Re: Minor Project Refinement No. 14 for the TL 6975 San Marcos to Escondido Project

TL6975 San Marcos to Escondido 69 kV Project CPUC Minor Project Refinement Form

Report No.: 14

ATTACHMENT B
MPR-14 Figure

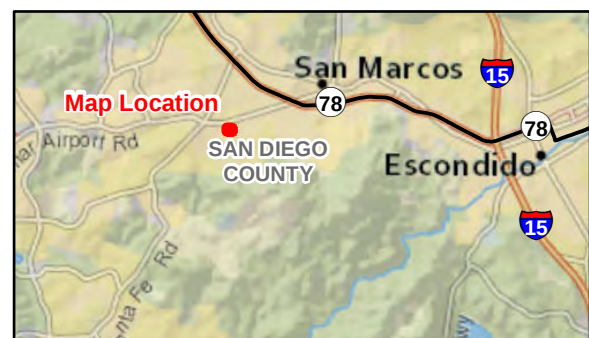
- Location 4 Proposed Modifications:** An additional 28 square-foot permanent work area will be required at Location 4, where the existing sidewalk will be extended on the south side of the pole within County ROW. The pole will no longer be installed in the location shown in Notice to Proceed No. 1 (NTP-1) and IS/MND mapping, approximately 8 feet southeast of

the existing pole. Instead, the pole will be set within the same location where the existing pole is located. There is no vegetation removal anticipated as a result of these modifications.

- **Location 5 Proposed Modifications:** The new pole at Location 5 will be installed approximately 35 feet southeast of the original location shown in NTP-1 and IS/MND mapping. An additional 206 square-foot permanent work area will be required at Location 5, where the existing sidewalk will be extended within County of San Diego ROW. An additional 915 square-foot temporary work area will be required at this location to complete the pole installation and sidewalk extension. The ornamental grass within the permanent portion of the work area will be removed.

- **Location 6 Proposed Modifications:** The new pole at Location 6 will be installed approximately 4 feet southeast of the original location shown in NTP-1 and IS/MND mapping. An additional 58 square-foot permanent work area will be required at Location 6, where the existing sidewalk will be extended within County of San Diego ROW. An additional 609-square-foot temporary work area will be required at this location to complete the pole installation and sidewalk extension. The ornamental grass within the permanent portion of the work area will be removed.

During final engineering it was determined that the optimized location for the new pole at Location 6 would fall over the existing sidewalk in the location shown in **Attachment B, MPR-14 Figure**. This shift would be required in order to keep the pole in line with the existing overhead alignment. The original pole location at Location 6 also conflicted with existing underground conduits, and the new location would avoid these conflicts. Once it was determined the pole at Location 6 would be moved, engineering determined the pole locations for Locations 4 and 5 would also be shifted in order to align with Location 6. As a result of the movement of these pole locations, the existing sidewalk must be extended in order to allow pedestrian flow around the new pole sites, and to meet ADA sidewalk clearance requirements.
